AC Disconnect & more...

Roger Karam

Las Vegas Interim

Testing Summary

Test 7 - Rise Time

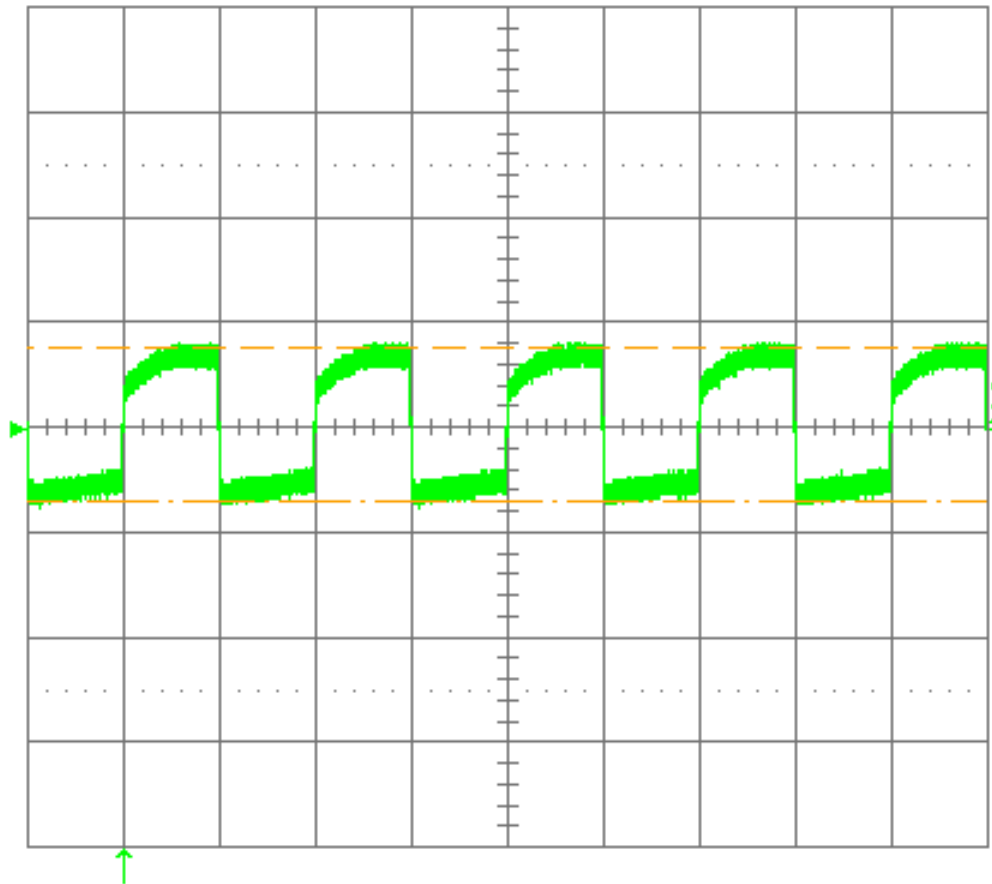
- Interaction of rise-time and PD power input load
- For rise-times of 10's uSec the EMI profile **May be** affected by the load
- so what load does the PSE vendor test to??

- slow down rise-time to mSec. As large as feasible within the 500mSec detection window

Rise-time AC Disconnection signal with PD-2

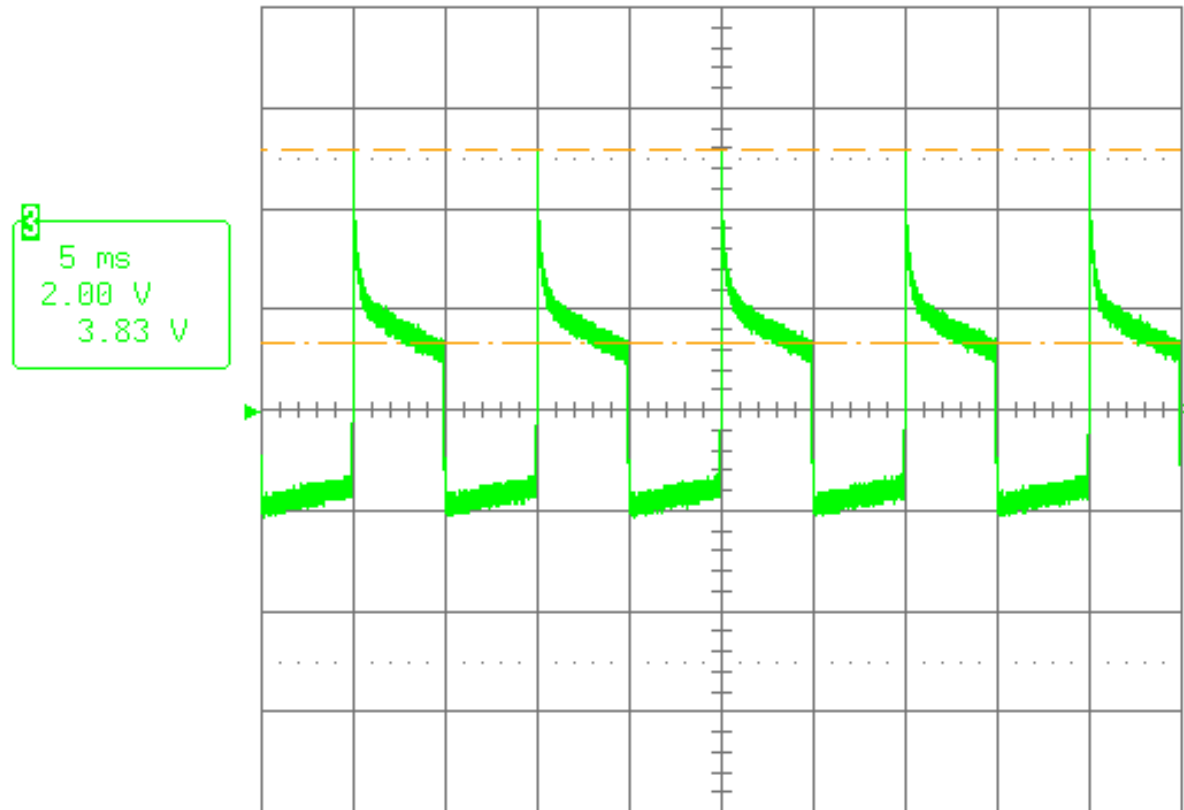
T_{rise} = 10 uSec
PD no. 2 is OFF

Spectrum got worse

Test 8 - PSE-PSE DC detection

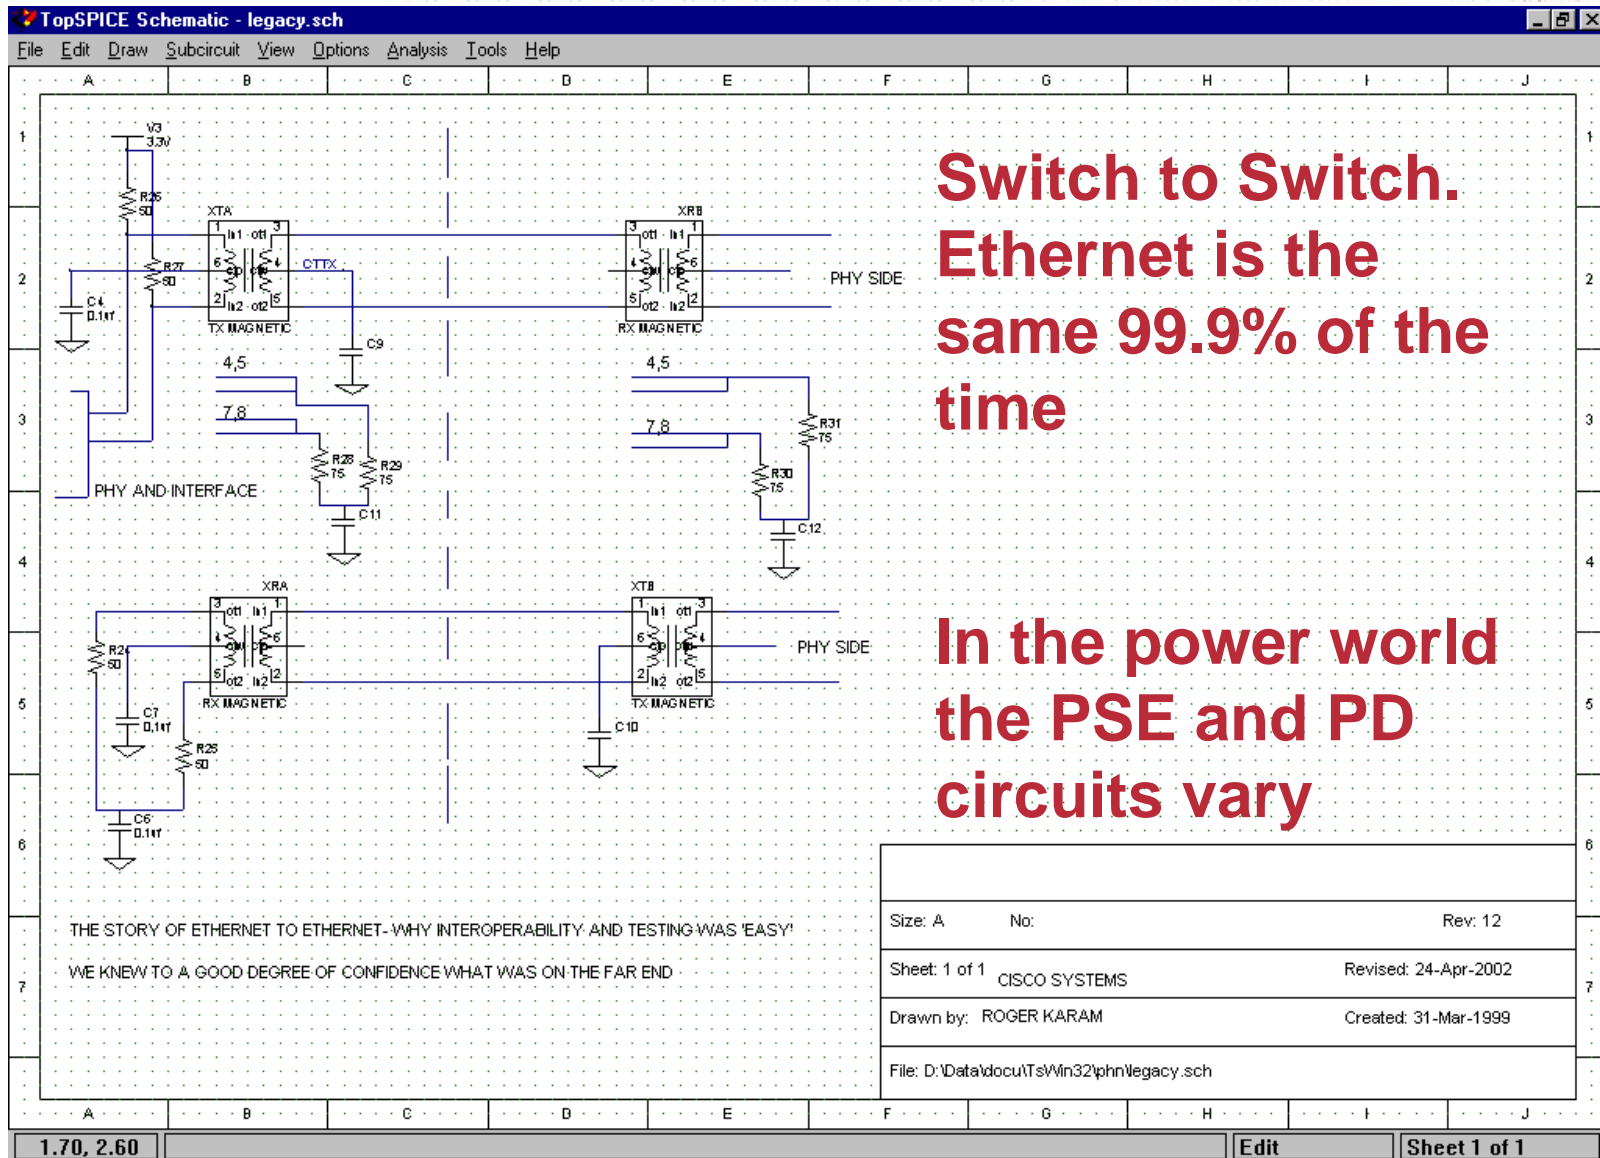
- Is this really a DC detection scheme. It turns out that many implementations are switching rapidly between the two probing voltages (AC) at an unspecified frequency and duty-cycle with aggressive rise-times
- Ethernet interoperability

- Should not go to 2nd probe voltage until a possible PD is discovered at the 1st probe voltage (preferred solution – real DC)
- Specify the switching rate (not clean)

PSE – PSE Setup 1 Test Results

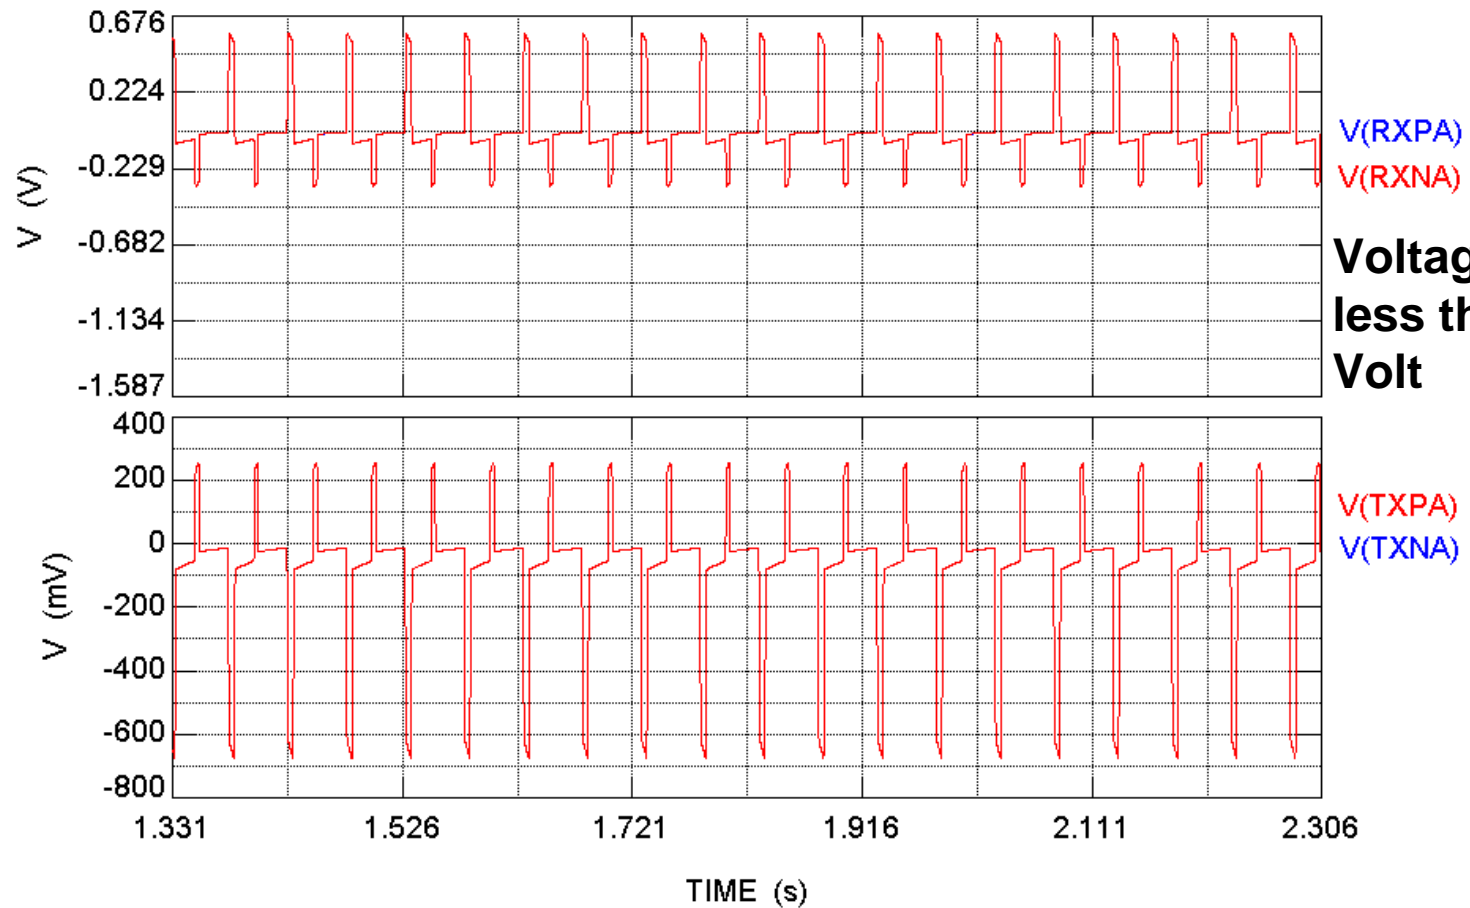
CASE 3 Both PSEs ARE DETECTING USING A 12V SWING.

**Voltage is
less than 1
Volt**

PSE – PSE Setup 2 Test Results

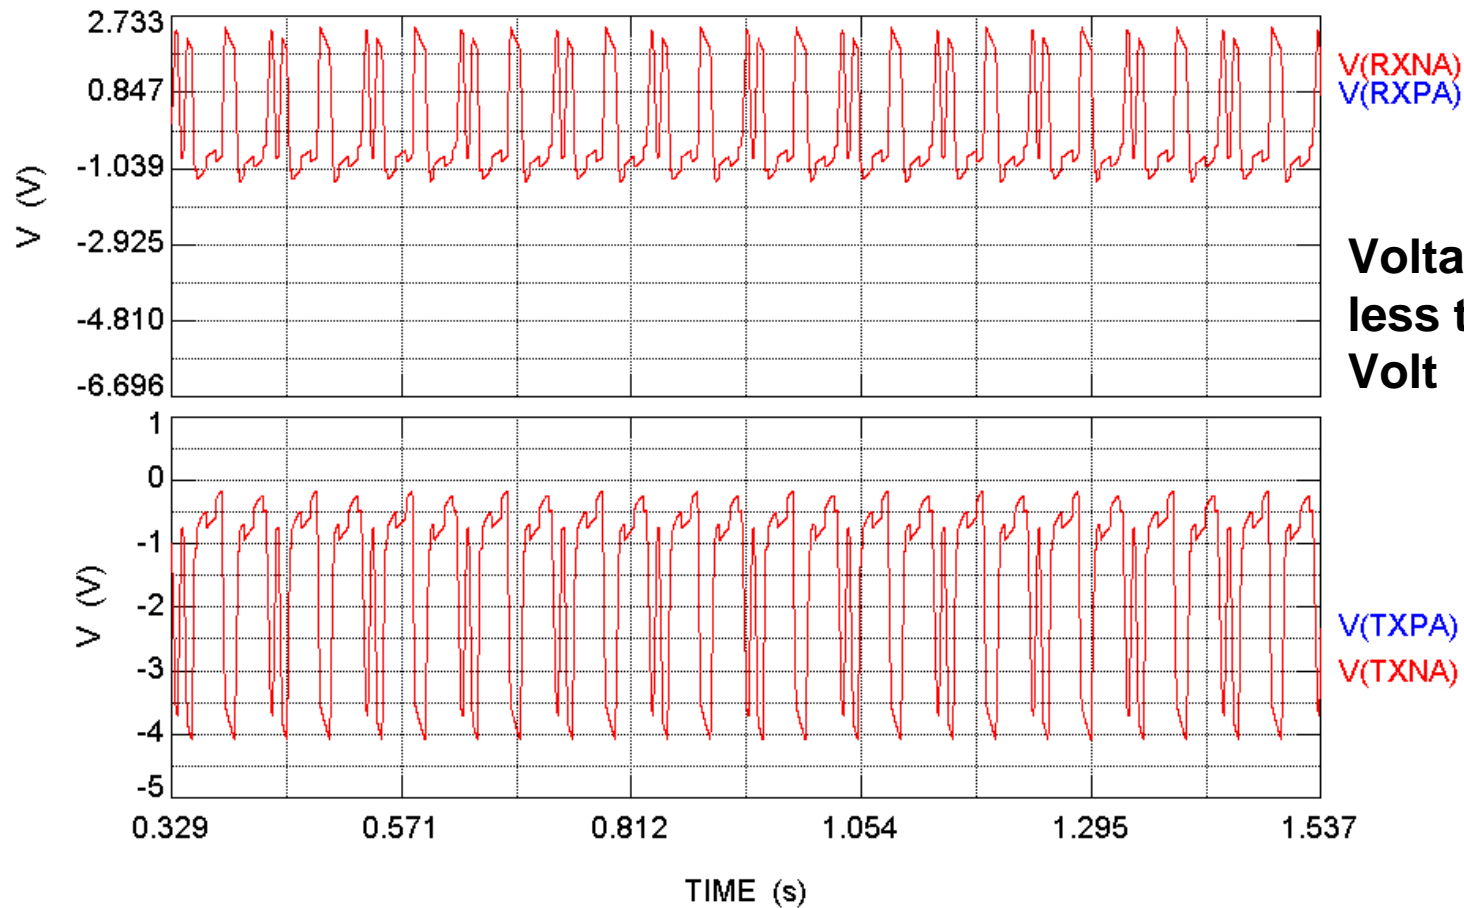
CASE 3 REVB, NOTE THE CHANGE TO THE TR, TF- Duty Cycle & Freq
OF VDET B So It Does Matter What Each Side is doing after all !?

**Voltage is
less than 5
Volt**
